Model: V-C3	Date: 11-Dec-09	No.: RD081001c
-------------	-----------------	----------------

Subject: Firmware Release Note: Printer		Prepared by: T. Toriumi	
From: 1st Overseas Tech Support Sec., 1st PQM Dept.			
Classification:	<input type="checkbox"/> Troubleshooting	<input type="checkbox"/> Part information	<input type="checkbox"/> Action required
	<input type="checkbox"/> Mechanical	<input type="checkbox"/> Electrical	<input type="checkbox"/> Service manual revision
	<input type="checkbox"/> Paper path	<input type="checkbox"/> Transmit/receive	<input type="checkbox"/> Retrofit information
	<input type="checkbox"/> Product Safety	<input checked="" type="checkbox"/> Other (Firmware)	<input checked="" type="checkbox"/> Tier 2

This RTB has been issued to announce the firmware release information for the **Printer**.

New illustration for DIP SW settings

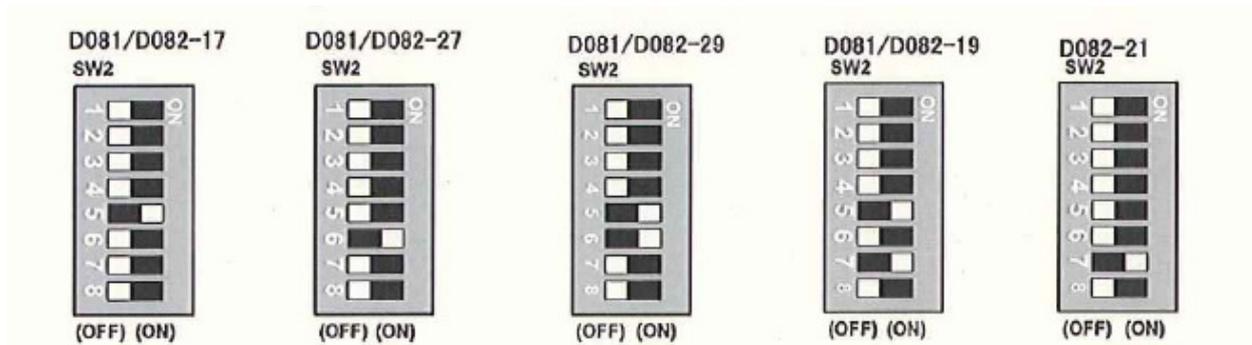
Replace the illustration shown below (regarding the DIP SW settings on the VBCU) in the D081/D082 FSM (Pg. 458).

**V-C3 Parts Catalog**

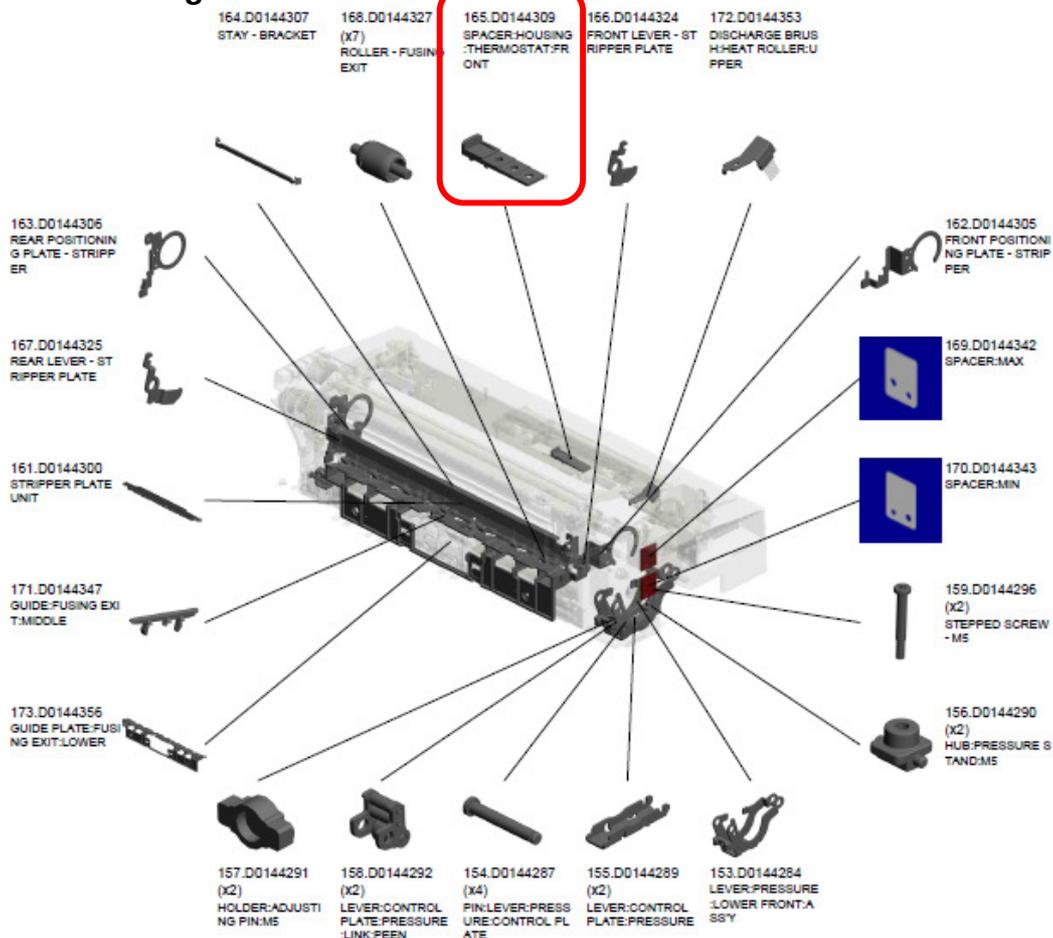
The attachment position for **SPACER:HOUSING:THERMOSTAT:FRONT (Pg.182, Index#165)** is decided, so **be sure to attach this part in the correct position** any time in the field.

**Reason:**

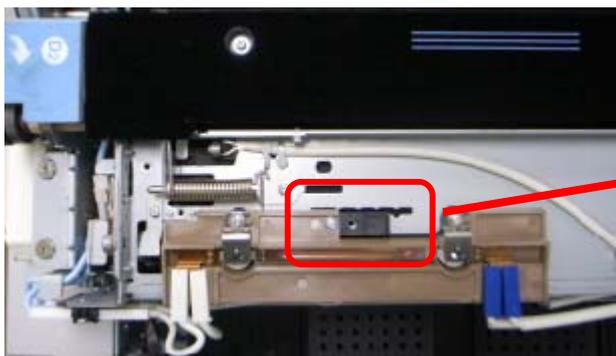
This part adjusts the height between Fusing Belt and Thermostat.

If this part is attached in an incorrect position, the thermostat might **NOT** function correctly.

**SYMPTOM**

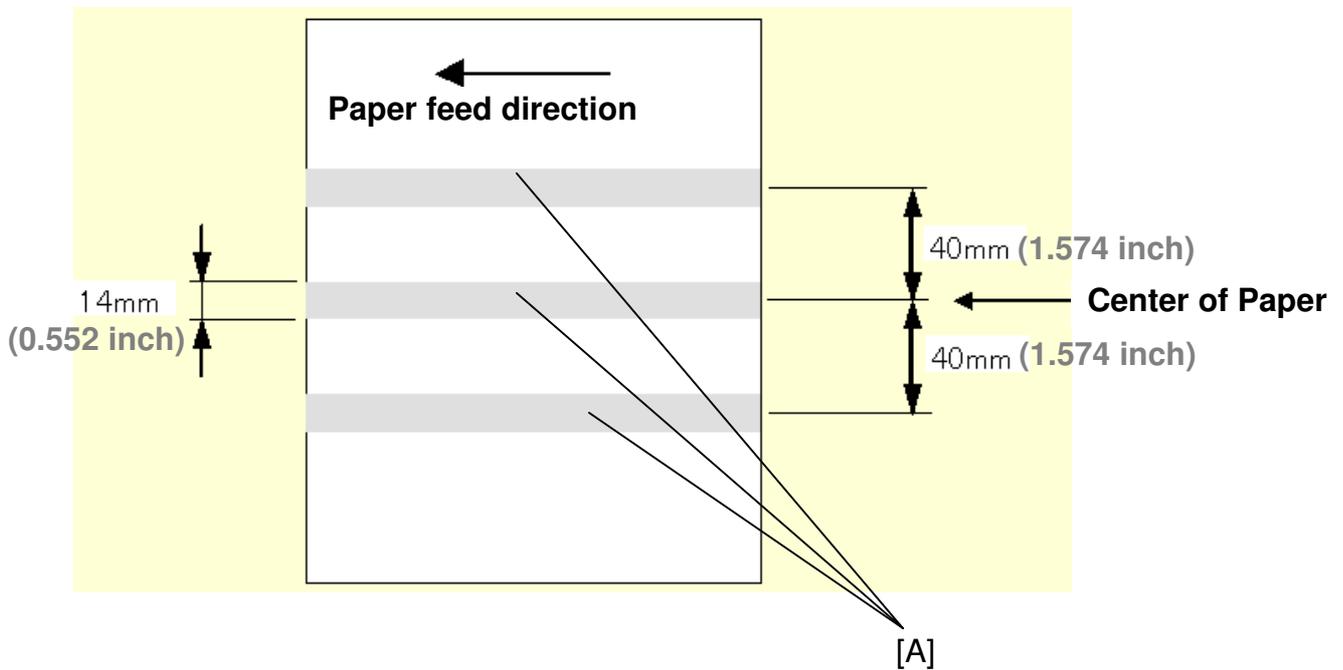
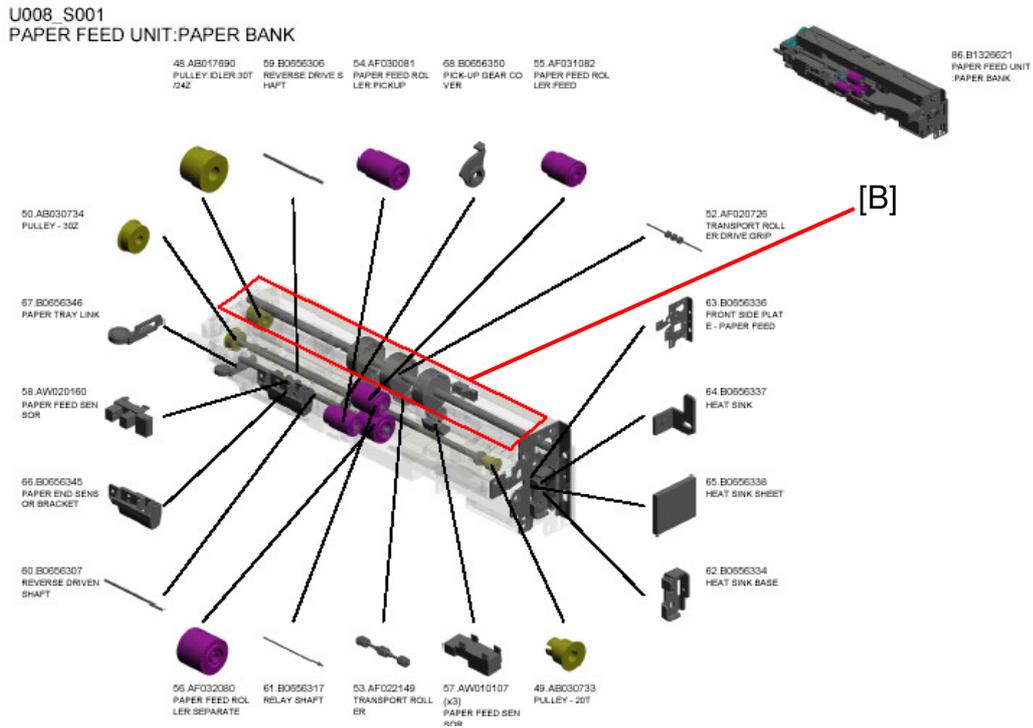
Dirty horizontal bands [A] appear at intervals of 40mm, especially under low-temperature conditions.

Under low-temperature conditions, paper dust tends to build up on the ITB and ITB cleaning blade (especially in the area corresponding to the position of the Paper Feed Roller [B] in the paper feed unit). These areas are damaged, and this appears on the paper as horizontal bands.

Installation

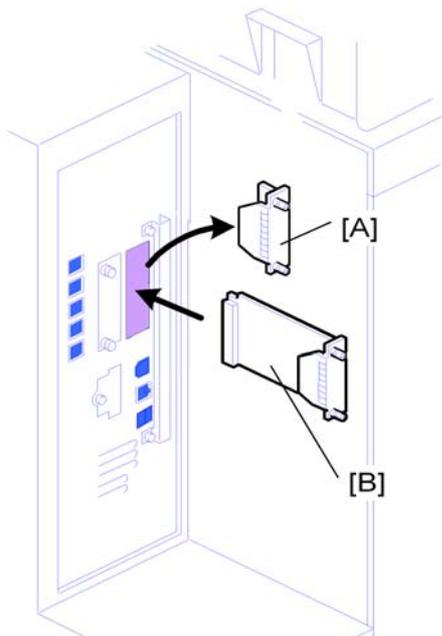
**Delete** Steps 6 and 7, as shown below.

1. Remove the cover of Slot **A** [A] (🔧 x2).
2. Touch a metal surface to discharge any static electricity from your hands.
3. Put the interface board [B] in Slot B.
4. Confirm that the board is inserted completely, then fasten it (🔧 x 2).
5. Turn the machine off and on.
- ~~6. Enter the SP mode and do SP5990 to print an SMC Report.~~
- ~~7. Read the report and confirm that the interface board is installed correctly.~~

***Parts Change Information #02***

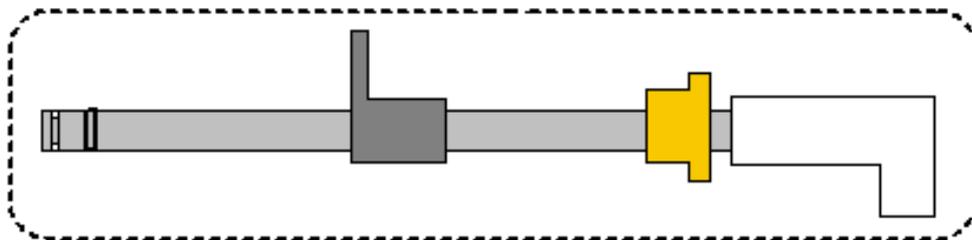
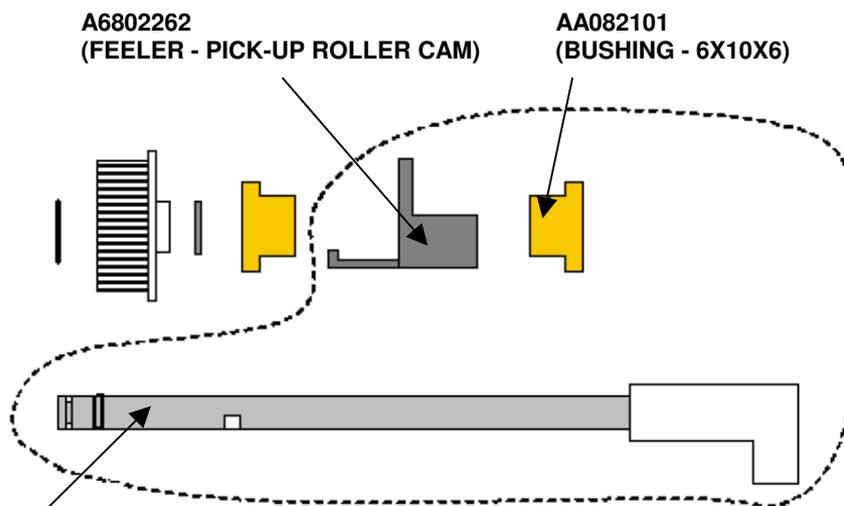
***Parts Change #01 was issued, but the New part (D4121682) cannot improve chattering. Also, D4121682 has not been installed on mass-production machines and not shipped to overseas SPCs yet. So we are issuing Reversed Parts Change #02 in this RTB.***

**Change:** ***The feeler, pick-up roller cam, and bushing were re-registered as individual service parts.***

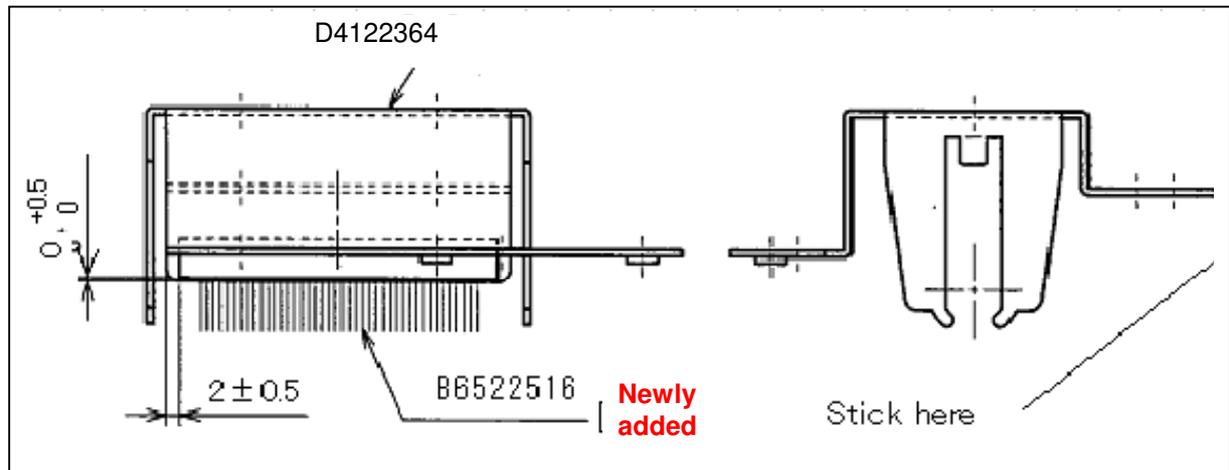
**Change:** A static discharge brush was added to the bracket (P/N: D4122364).

New Part: D4125505

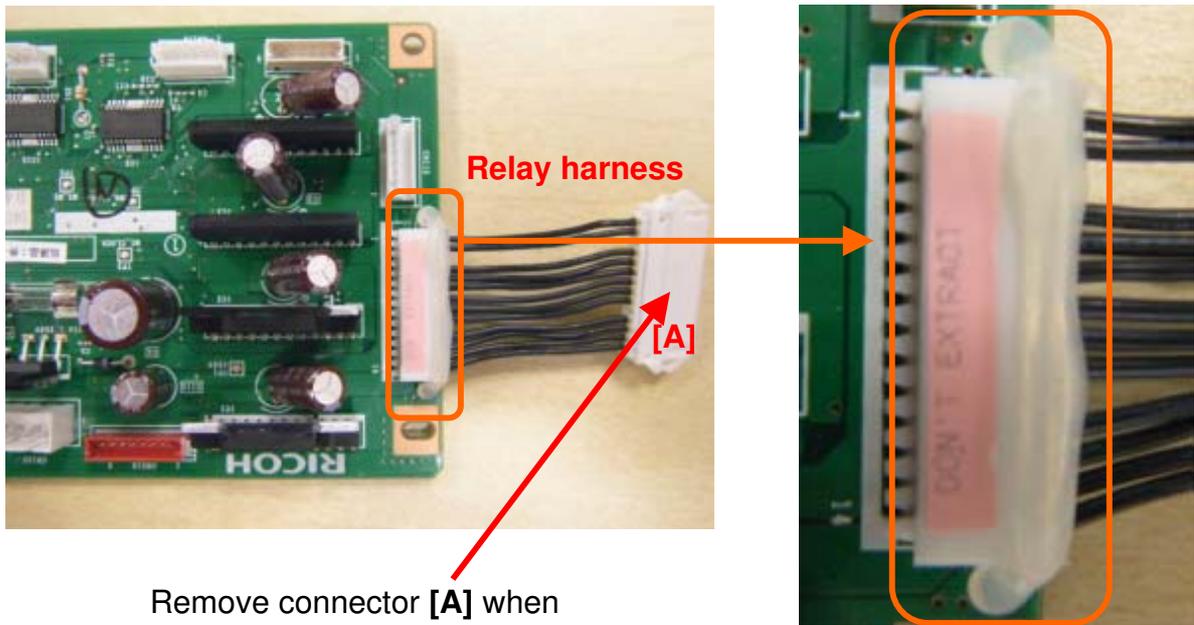
**Change:** The insertion slot for CN113 is attached with the pins parallel to the PCB (see the photo below).

- Before the change is applied to the production line, some machines have a temporary PCB with a relay connector (see the photo and serial numbers below).
- If you replace this temporary PCB in the field, remove connector [A] of the relay harness when removing the board.

**Fig. 2: Button not displayed**  
System/Copy v1.02 or later

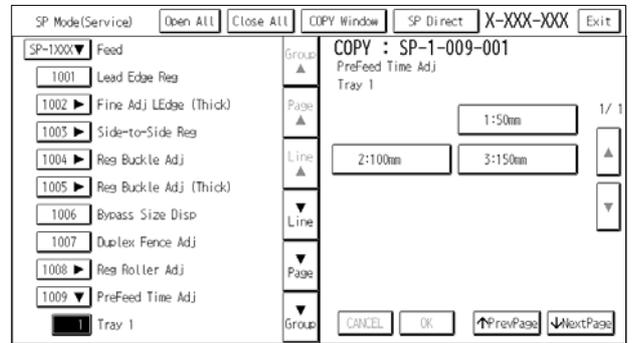
**Fig. 1: Normal display**  
System/Copy v1.01 or earlier

**TARGETS:**

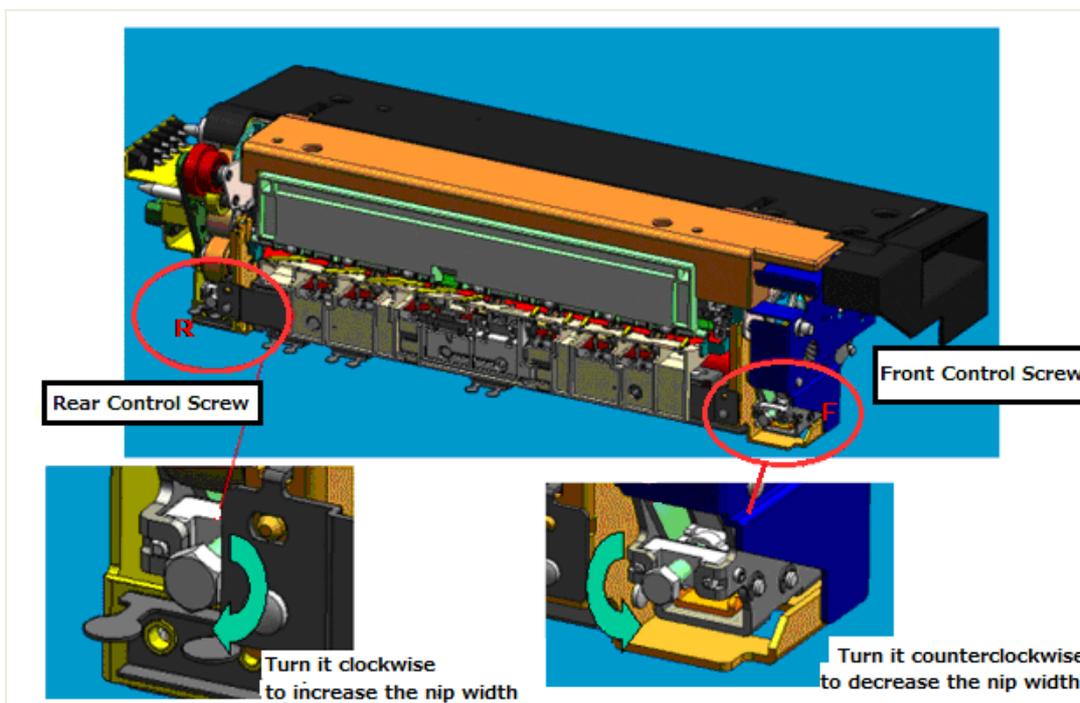
- Center nip width: **13.5 ± 0.5mm**
- Difference between front and rear nip widths: **± 0.5mm**
